# UNITED STATES PATENT AND TRADEMARK OFFICE

APPLICATION NO.	FILING DATE	FIRST NAMED INVENTOR	ATTORNEY DOCKET NO.	CONFIRMATION NO.
10/024,869	12/19/2001	Rene Jean Zimmer	DN2001205	3717

<b>Office Action Summary</b>	<b>Application No.</b> 10/024,869	<b>Applicant(s)</b> ZIMMER ET AL.	
	<b>Examiner</b> Steven D. Maki	<b>Art Unit</b> 1733

- 2) **Claims 1-13 and 15-16 are rejected under 35 U.S.C. 103(a) as being unpatentable over Ohsawa (US 2001/0032691) and optionally Heinen '100 (GB 2363100) or Heinen '835 (US 6415835).**

FIGURE A ( $\alpha = 45^\circ$ )

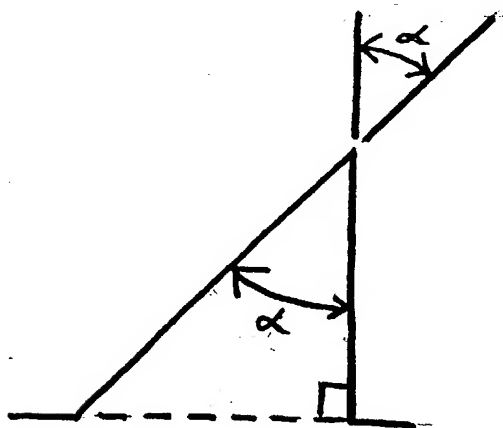
Applicant argues that the consequence of the invention is a projection having an undercut extending from the projection apex to its base. The examiner disagrees. The claimed invention requires an acute angle of 5-60 degrees instead of an undercut.

None of the claims require an undercut. As can be seen from the following illustrations:

the claimed requirement of an angle  $\alpha$  ranging from 5 to 60 degrees can be satisfied by (1) a projection as shown in figure A defining an angle 45 degrees but not having an undercut or (2) a projection as shown in figure B defining an angle  $\alpha$  of 53 degrees but not having an undercut.

FIGURE C

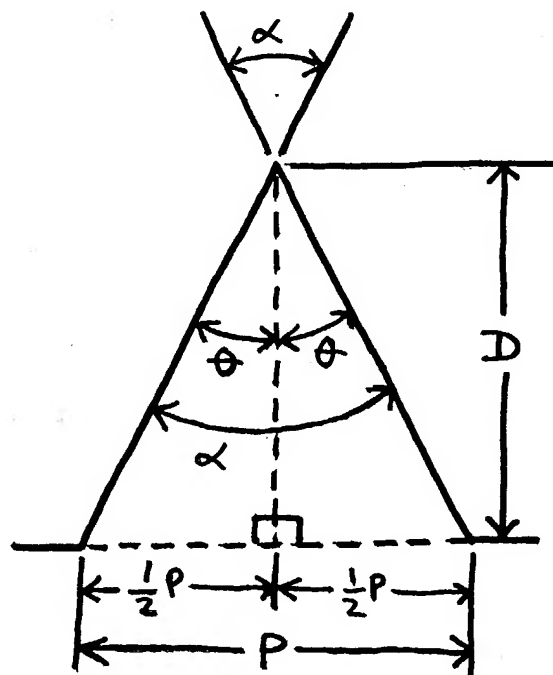
Applicant argues that Ohsawa fails to teach or suggest a projection having an angle of 5-60 degrees (an inclination falling within the claimed invention specifications). Applicant is incorrect. An illustration of one of Ohsawa's triangle projections is provided below:

In the tire of Example 1, the depth  $D$  is 0.05 mm (50 micrometers) and the pitch  $P$  is 0.05 mm (50 micrometers). See paragraph 258. Since depth  $P = D$  in Example 1,

Ohsawa's formula  $P \leq 2D$  is satisfied. With reference to the above noted figure C, angle  $\theta = 26.6$  degrees ( $\tan \theta = 0.025 \text{ mm} / 0.05 \text{ mm}$ ). Since "angle  $\alpha$ " equals  $2\theta$ , the "angle  $\alpha$ " is 53.2 degrees (falling within the claimed range 5-60 degrees).
